COMAL COUNTY

ENGINEER'S OFFICE

119101.pdf Markup Summary 10-30-2025

**COMAL COUNTY**
ENGINEER'S OFFICE**ON-SITE SEWAGE FACILITY APPLICATION**195 DAVID JONAS DR
NEW BRAUNFELS, TX 78132
(830) 608-2090
WWW.CCEO.ORGDate 10-02-25Permit Number 119101**1. APPLICANT / AGENT INFORMATION**Owner Name CAREN LLIZBET CASTILLO DOMINGUEZ
Mailing Address 329 WREN CIRCLE
City, State, Zip SPRING BRANCH TX 78070
Phone # 830-302-9732
Email CARENC64@GMAIL.COMAgent Name THALIA RIVAS
Agent Address PO BOX 768
City, State, Zip SPRING BRANCH TX 78070
Phone # 726-348-0132
Email RS.TR@OSSFDESIGNS.COM**2. LOCATION**Subdivision Name REBECCA CREEK PARK THIRD FILING Unit _____ Lot 19 Block 60
Survey Name / Abstract Number _____ Acreage _____
Address 329 WREN CIRCLE City SPRING BRANCH State TX Zip 78070**3. TYPE OF DEVELOPMENT**☒ Single Family ResidentialType of Construction (House, Mobile, RV, Etc.) MOBILE HOMENumber of Bedrooms 2Indicate Sq Ft of Living Area 900SF☐ Non-Single Family Residential

WASTEWATER TREATMENT SYSTEM MONITORING AGREEMENT

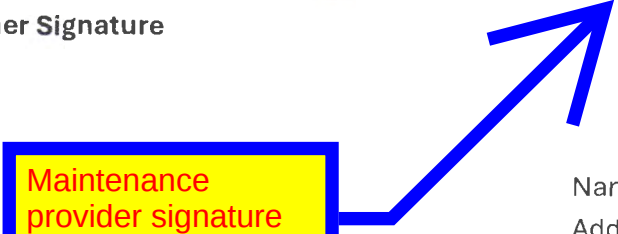
Maintenance provider signature needed.

OWNER: CAREN LIZBET CASTILLO DOMINGUEZ
LEGAL DESCRIPTION: LOT 19, BLOCK 60, REBECCA CREEK PARK THIRD FILING,
ADDRESS: 329 WREN CIRCLE SPRING BRANCH TX 78070
PREPARED BY: THALIA RIVAS RS 5067 SCALE: 1" = 25'

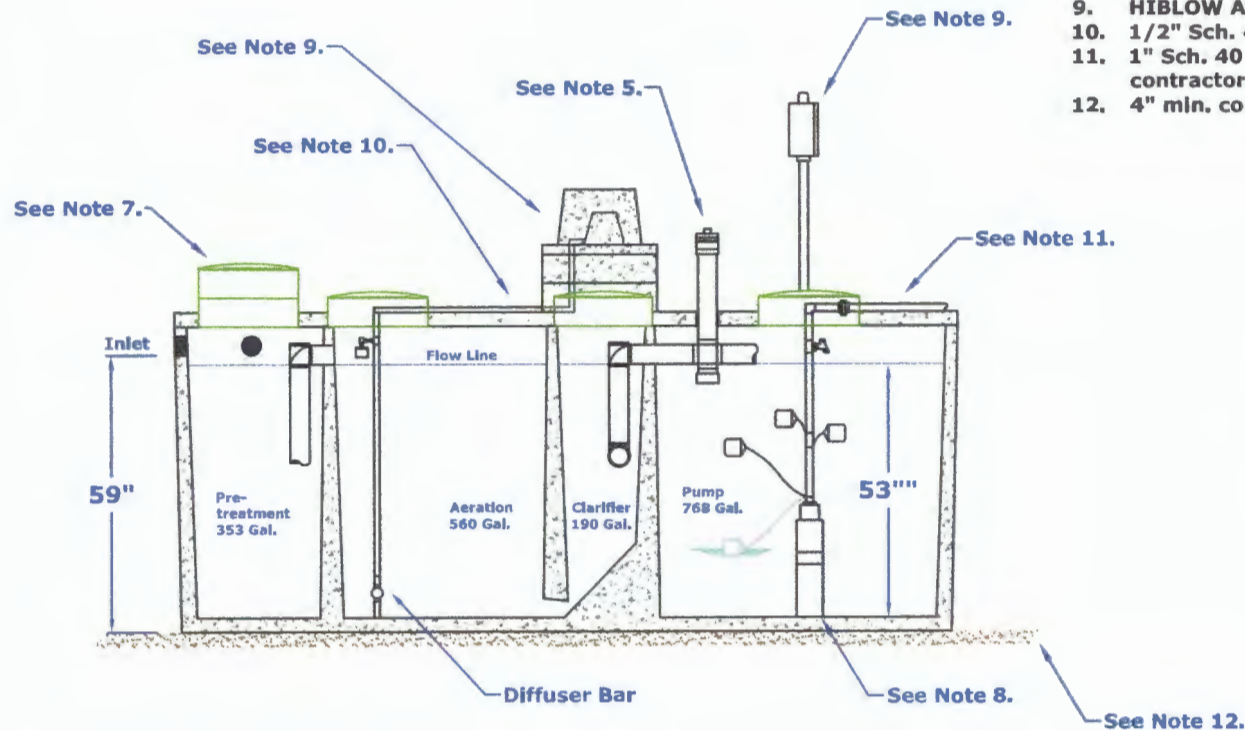
A preliminary inspection is scheduled for tomorrow. Additional comments may be necessary.
